# **Dewberry Response to USGS/FEMA Region 2 Review of the NY Great Lakes Area QL2 LiDAR - Orleans County Processing Project**

Produced for U.S. Geological Survey

Task Order:G14PD00043

Figure 3- Tile 17TQJ555005. Artifacts have been removed from the DEM surface. Top is before bottom is after.

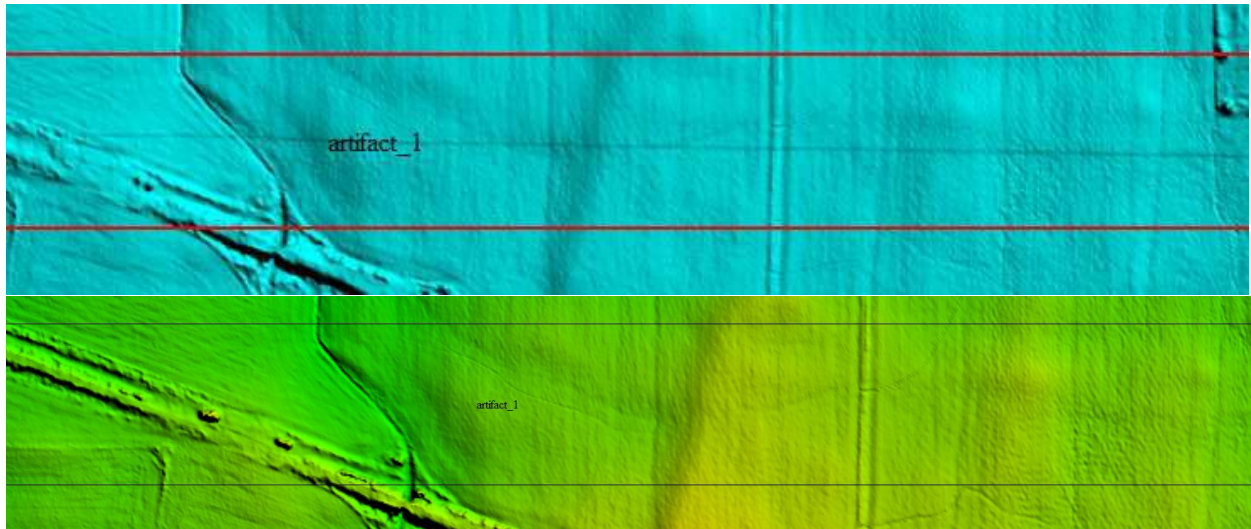
There were two locations where the USGS identified places that had what appeared to be artifacts and not represent the true ground surface.

Figure 4-Tile 17TQJ450020. No additional points can be removed from ground classification. Bridge “saddles” are a visual artifact resulting from interpolation of a continuous surface. Breaklines are placed to remove “saddles” in the DEM.

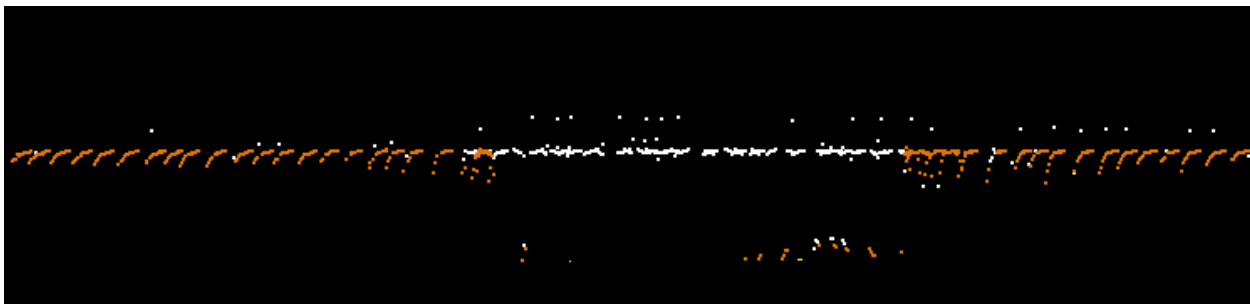
There were seven locations where USGS made calls regarding visual artifacts. The DEM surface models are created from TINs or Terrains. TIN and Terrain models create continuous surfaces from the inputs. Because a continuous surface is being created, the TIN or Terrain will use interpolation to triangulate across a bridge opening from legitimate ground points on either side of the actual bridge. This can cause visual artifacts or “saddles.” These “artifacts” are only visual and do not exist in the LiDAR points or breaklines. No points were modified in these locations. Breaklines were placed to remove the “saddles” in the DEM.

Figure 5-Tile 17TQH210885. Culverts have been reclassified from class 1 (white) to ground (orange).

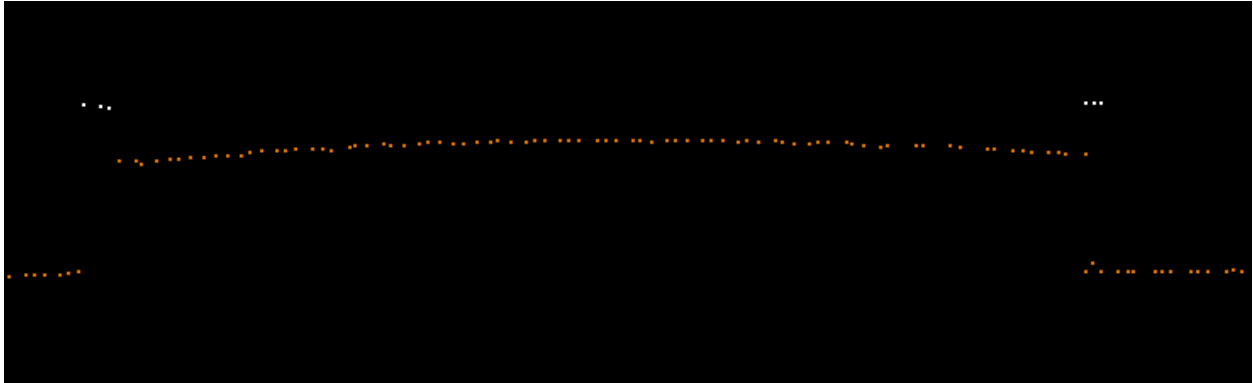
There was one locations where Dewberry interpreted a feature as a bridge and removed it from the ground surface. USGS identified these features as culverts, not bridges. Dewberry has modified the points and added these features to the ground surface. An example is shown below.

Figure 6-Tile 17TQH345975. All possible points have already been moved to ground (orange). No modification required as no new points to add to the ground surface.

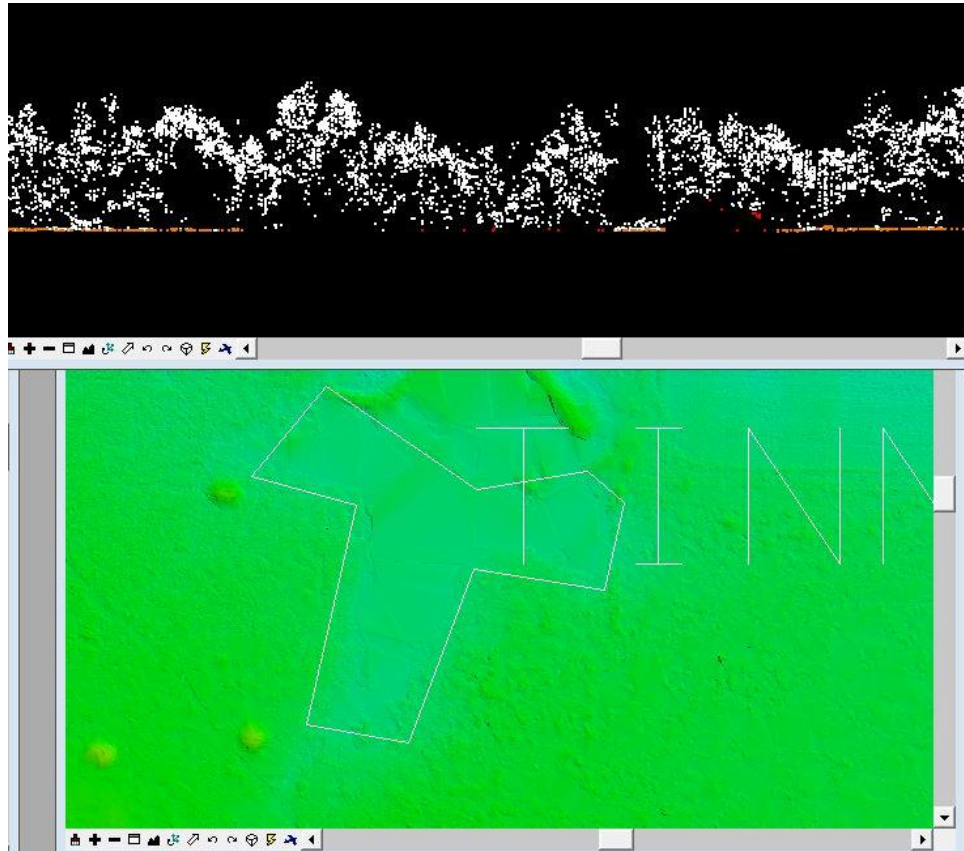
There were twenty five calls to bring back more ground in vegetated areas. In most areas there were no extra ground point to add back to the surface. Attempts were made to add points if possible, but DEM surfaces still look very similar. Examples are shown below.

Figure 8 – Tile 17TQH300960. An additional pond breakline has been collected for this feature and used to flatten the feature in the redelivered DEM. The LAS has been corrected to reflect the addition of this feature.

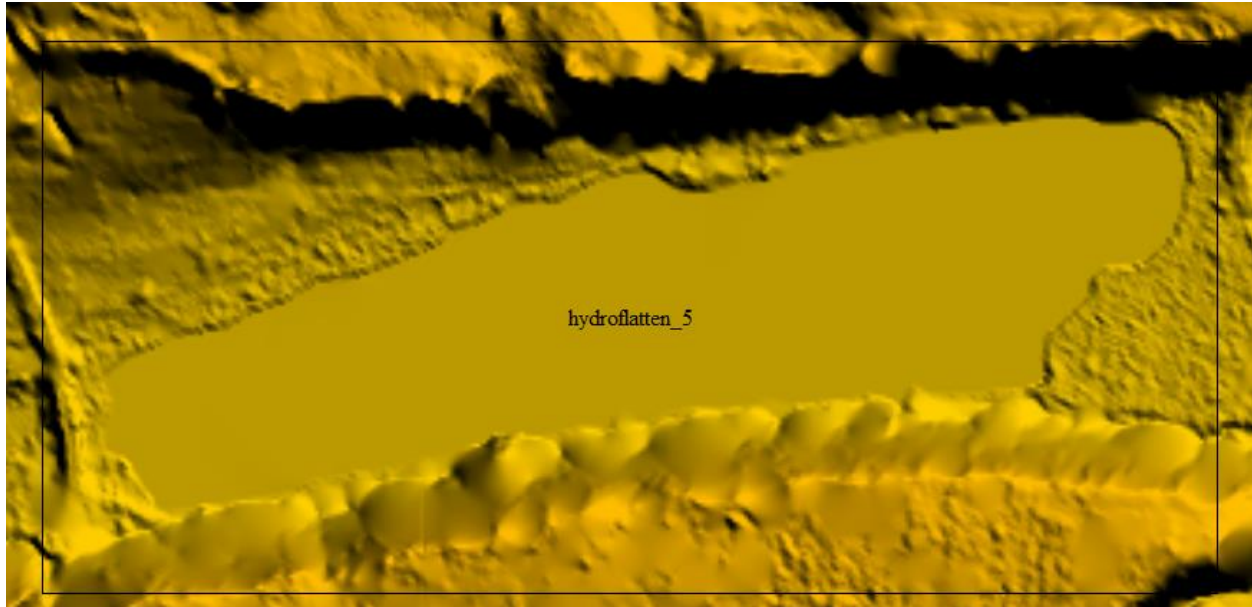
There were 7 locations where USGS identified areas of water that were not included in the collected breaklines. While the interpretation of the feature may be questionable in the intensity imagery, Dewberry agrees with all seven calls after reviewing color imagery and the available LiDAR points.

Figure 9 – Tile 17TQH210930. The area called out as part of a building being left in the ground (orange) is part of a berm built up behind the structure.

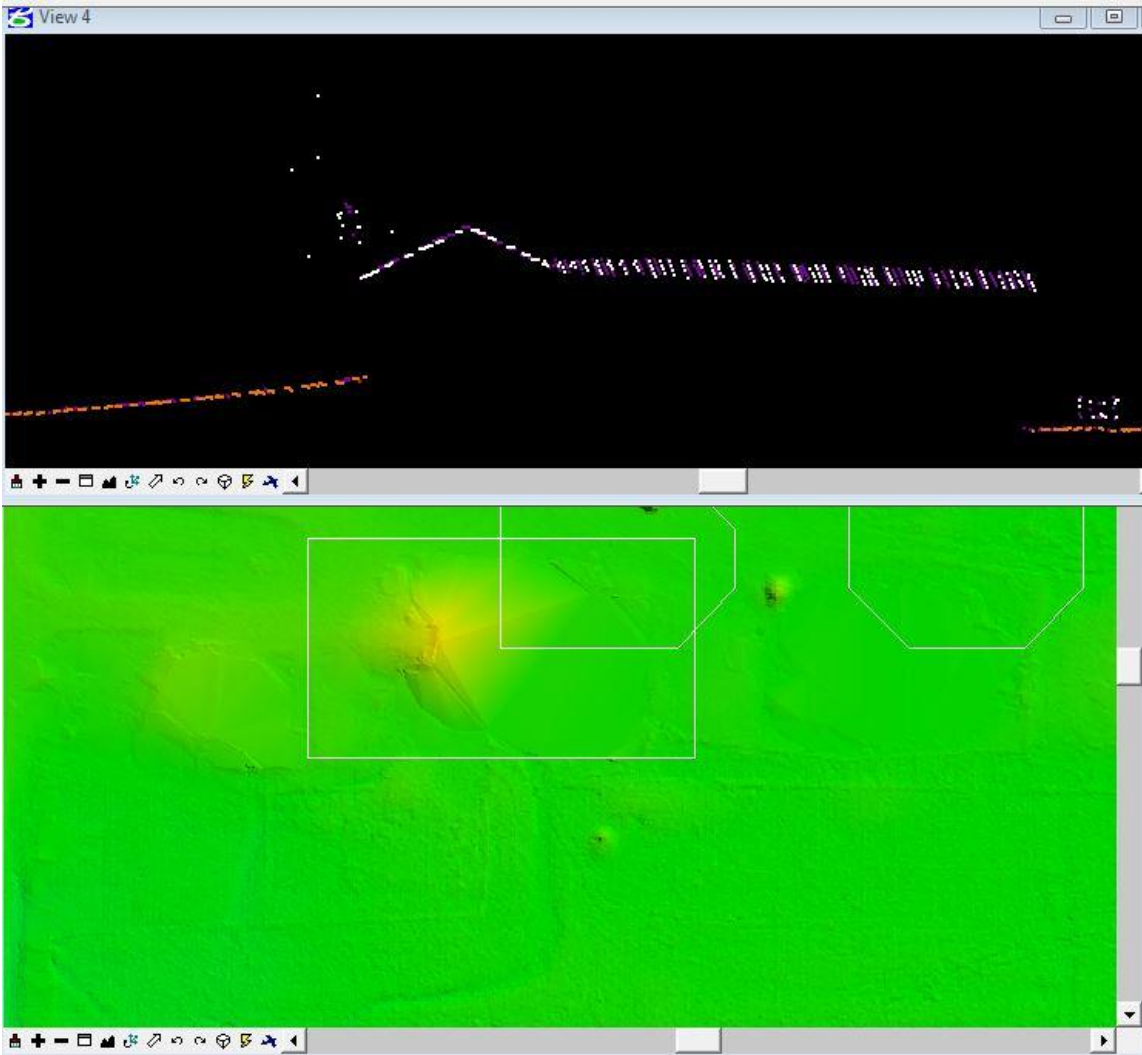
There were three locations where the USGS identified places that had what appeared to be buildings left in the ground surface and not represent the true ground surface. Two of the calls had the point adjusted and one was not changed because the points are part of a ground feature see screen shot below.
